Circle Square No.3

Landscape Design & Access Statement Addendum

<u>File Name</u>	<u>Prepared by</u>	<u>Checked by</u>	<u>Date</u>
L014-PIE-90-ZZ.00-T-L-000016-03 Landscape Design Non-Material Amendment Application	VE	RM	09-07-25

View of Bee sculpture within Symphony Gardens

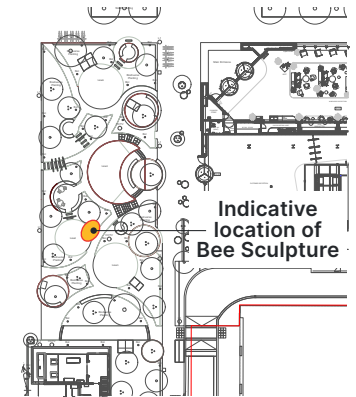
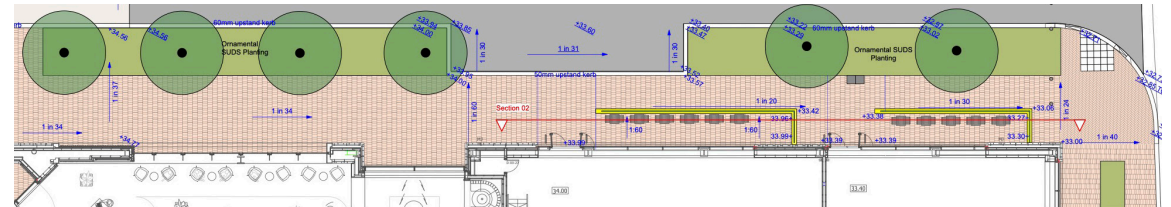
Now that they are relocating to Circle Square, they would like to bring the Bee with them and showcase it within the new Symphony Gardens.

The inclusion of the Bee within Symphony Gardens will add a key focal point and feature to the landscape. The bright colours of the sculpture will be glimpsed through the tree canopies and draw people into the space.

The sculpture will be nestled within shrub planing on the edge of a lawn area, a natural place to stop, dwell and observe. The bold colours of the Bee will be softened by the lush green backdrop of the surrounding planting.

Detail Plan - Spill Out Terraces along Newman Street

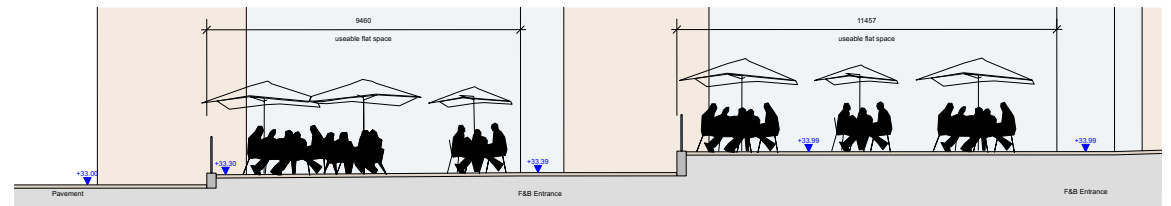
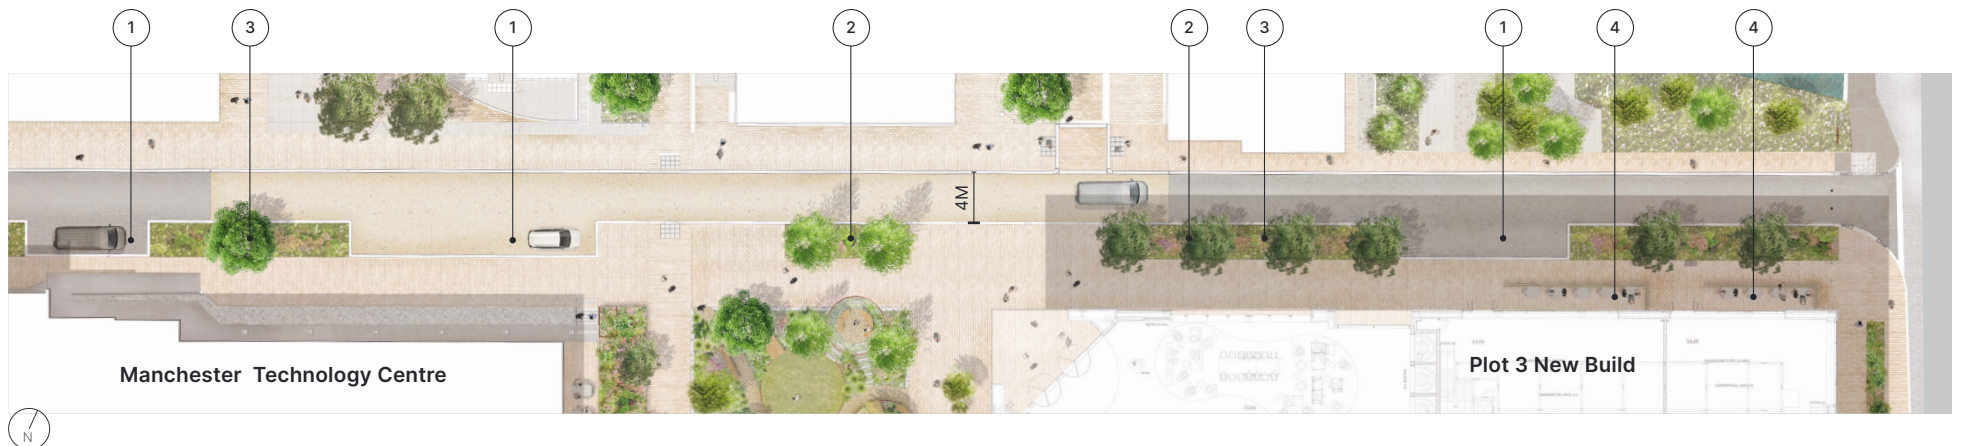
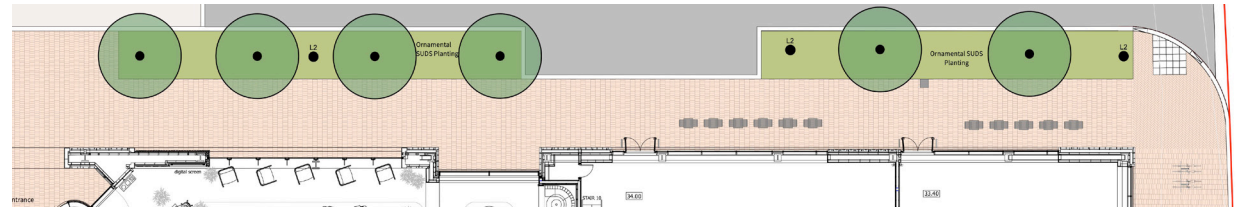
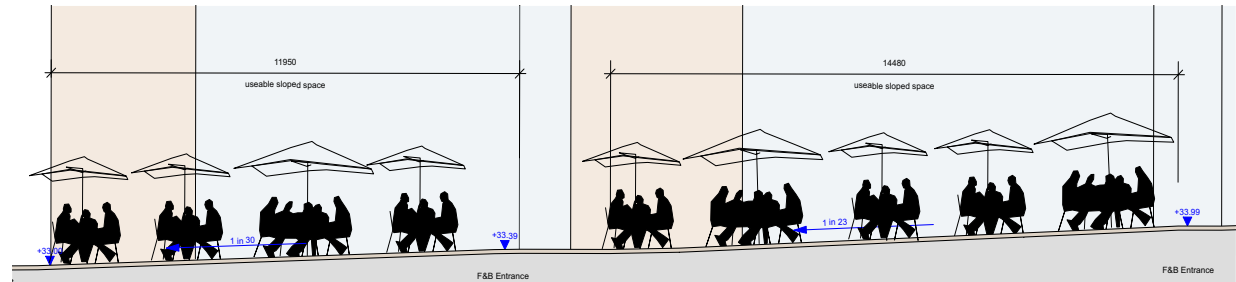
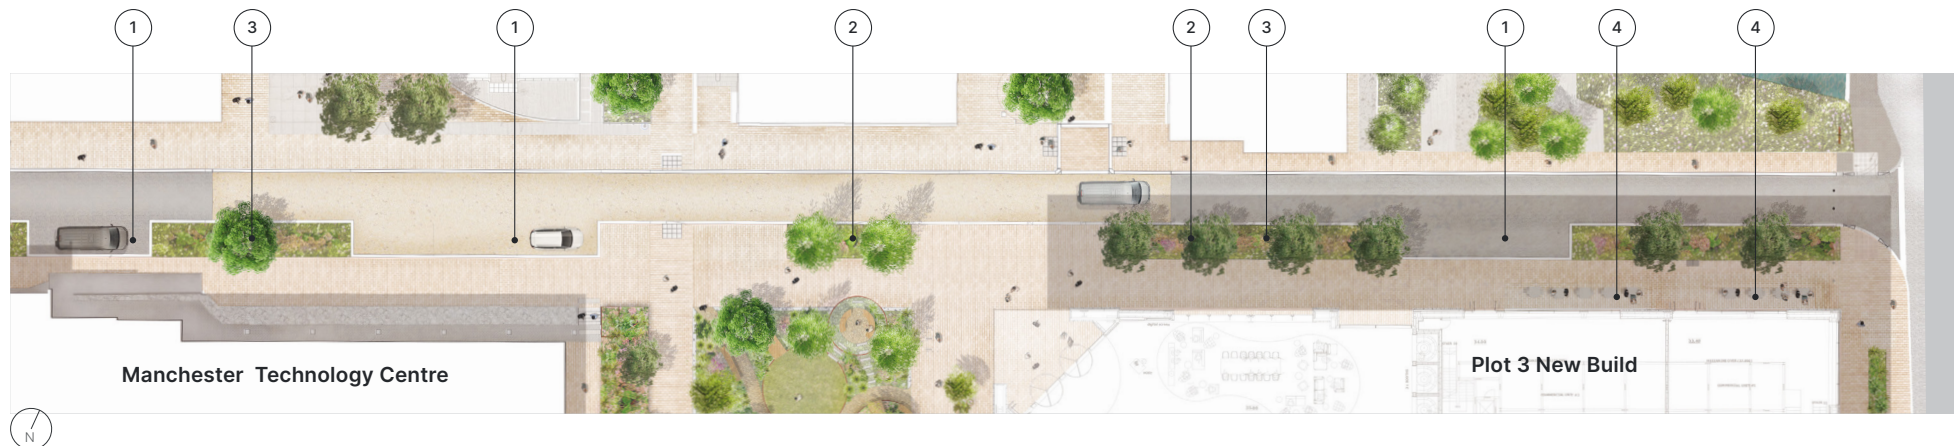
The approved plan proposed two 2m wide terraces, along the Newman Street building facade. The terraces would provide spill out opportunity for Circle Square No.3 Commercial Units 1 & 2.

The terraces would achieve a level zone for tables and chairs enclosed with a retaining wall and glazed balustrade screen.

Level access terraces to the Circle Square No.3 commercial units have been omitted during the design development process.

By losing the terraces, spill out spaces for the commercial units are maximised and not limited to the confines of a terrace with a dead end that restricts circulation.

This solution opens up the elevation of the building allowing for more engagement with the street scene. The footpath becomes more accessible with less obstacles or obstructions. Additionally, spill out becomes more flexible with further opportunity for events and increased space for tables and chairs.

Detail Plan - Spill Out Terraces along Newman Street

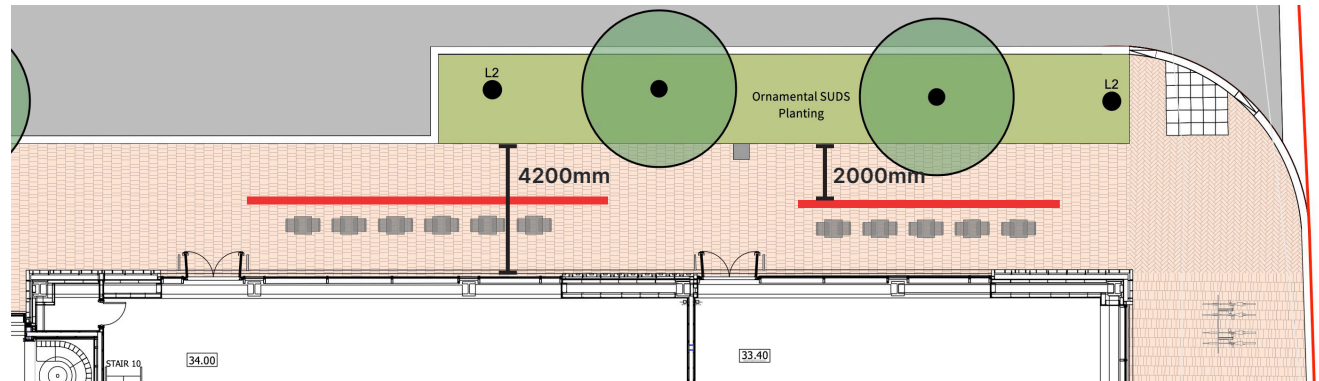
Removable barriers can be put in place to enclose the spill out zone and separate the area from the footpath. This will ensure a 2m clear route is maintained for pedestrian access and circulation,

Site photographs - installation of underground services

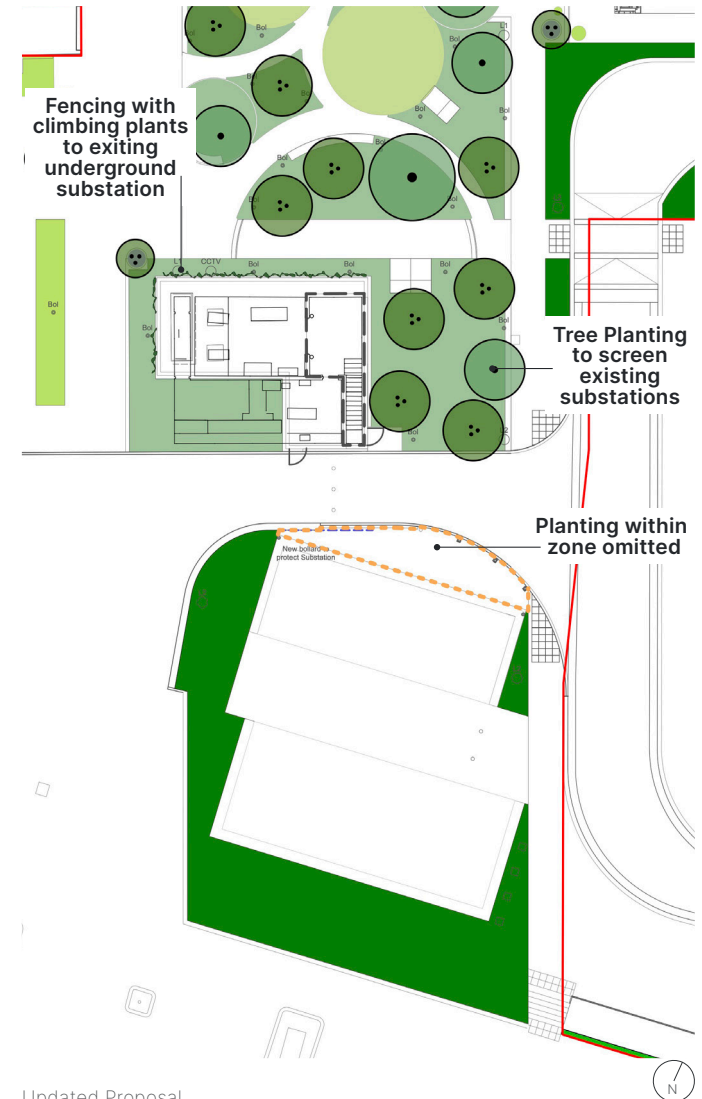
Runs of services were installed within the road and footpath in front of the substation building, as part of the early works of the development. The services are extensive in this area and are relatively shallow below ground level. Appropriate soil depth for shrub planting cannot be achieved here.

30m² of shrub planting has been omitted within this zone. The total area of shrub planting with the loss of 30m² is unchanged to what has been approved (under the original Planning Permission Ref: 134288/FO/2022).

Existing macadam surfacing to this area will be retained providing a robust and appropriate surface finish for the non-public facing service yard.
